Subject: HARD SHIFTING/SHIFT LEVER VIBRATION	Bulletin No: 05-001/15
	Last Issued: 11/11/2015

BULLETIN NOTE

- This bulletin supersedes the previous bulletins 05-008/14 issued on 07/14/14 and 11/26/14 and 05-001/15 issued on 01/05/15. The APPLICABLE MODEL(S)/VINS, DESCRIPTION, REPAIR PROCEDURE, PART(S) INFORMATION, and WARRANTY INFORMATION have been revised.
- Changes are noted below in Red beside the change bar.

Location of Transmission Related Parts

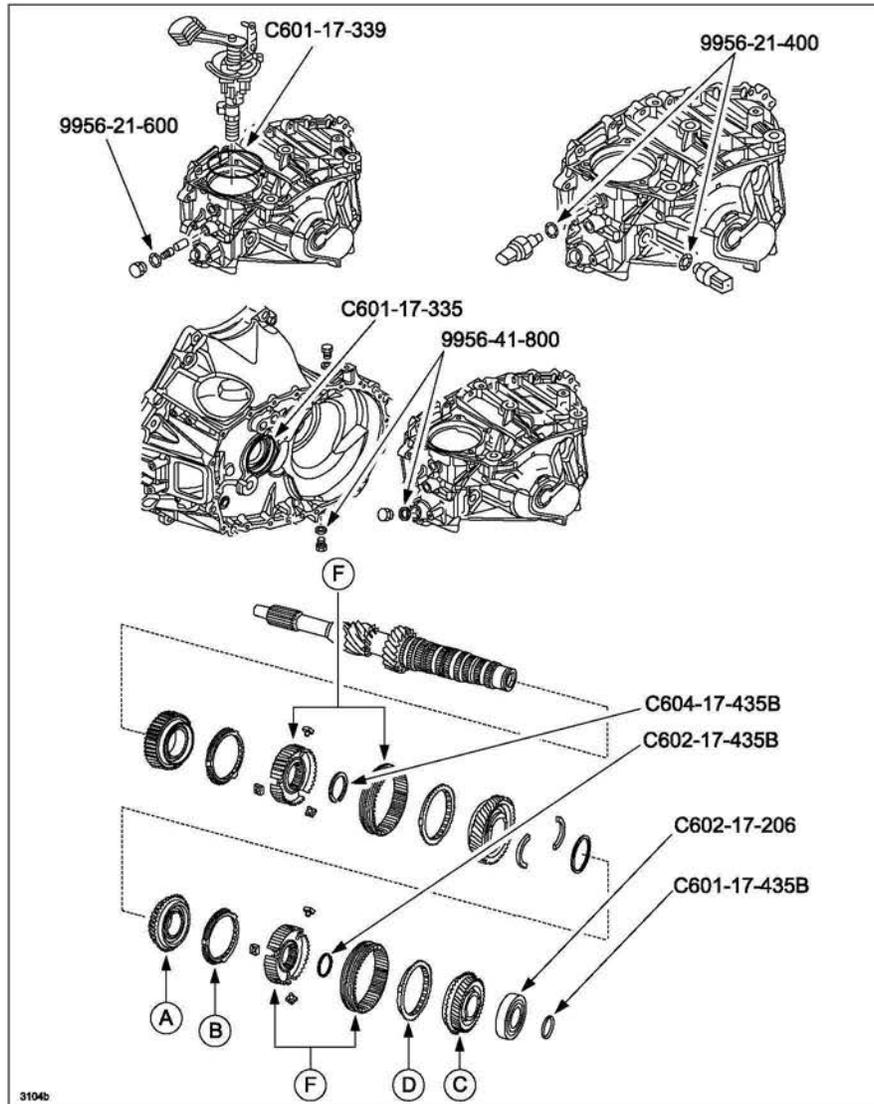
Modification	Mass-Production Change		Subject Concern
	Subject Part	Changes	
A	3-4 Clutch Hub	Surface treatment	Jumping out of gear
B	3-4 Clutch Hub 5-6 Clutch Hub	Shape	Hard shifting into 3rd, 4th, 5th and/or 6th gear
C	3rd and 4th Gears	Tolerance	Shift lever vibration
D	3rd and 4th Gears 3rd and 4th Synchronizer Rings	Shape	Hard shifting into 3rd and/or 4th gear (additional improvement)

VINs	Symptom			
	Gear jumping out (3rd Gear)	Hard shifting (5th or 6th Gear)	Hard shifting (3rd or 4th Gear)	Shift lever vibration (3rd or 4th Gear)
VINs before Modification A	Replace: 1) 3/4 Clutch Hub 2) 3rd Gear and Synch. Ring	Replace: 1) 5/6 Clutch Hub	Replace: 1) 3/4 Clutch Hub 2) 3rd Gear and Synch. Ring 3) 4th Gear and Synch. Ring	Replace: 1) 3rd Gear and Synch. Ring 2) 4th Gear and Synch. Ring
VINs between Modification A and B				
VINs between Modification B and C			Replace: 1) 3rd Gear and Synch. Ring 2) 4th Gear and Synch. Ring	
VINs between Modification C and D

Part Number	Description	Qty.	Notes
C602-17-240B	3-4 Clutch Hub Assembly	1	
C602-17-620B	5-6 Clutch Hub Assembly	1	
C601-17-230D C610-17-230C	3rd Gear	1	Part numbers of gears are different depending on the variation of the gear ratio. Check EPC for the correct part number for the repair VIN.
C602-17-26YB	3rd Synchronizer Ring	1	
C601-17-210E C603-17-210B C613-17-210B	4th Gear	1	
C602-17-26YB	4th Synchronizer Ring	1	
C601-17-435B	Retaining Ring	1	Replacement parts that are necessary for all repairs.
C604-17-435B	Retaining Ring	1	
D602-17-435B	Retaining Ring	1	
C602-17-206	Ball Bearing	1	
C601-17-339	"O" Ring	1	
C601-17-335	Oil Seal	1	
9956-21-400	Washer	2	
9956-21-600	Washer	1	
9956-41-800	Washer	2	
0000-77-5W80-QT	Manual Transaxle Oil	3
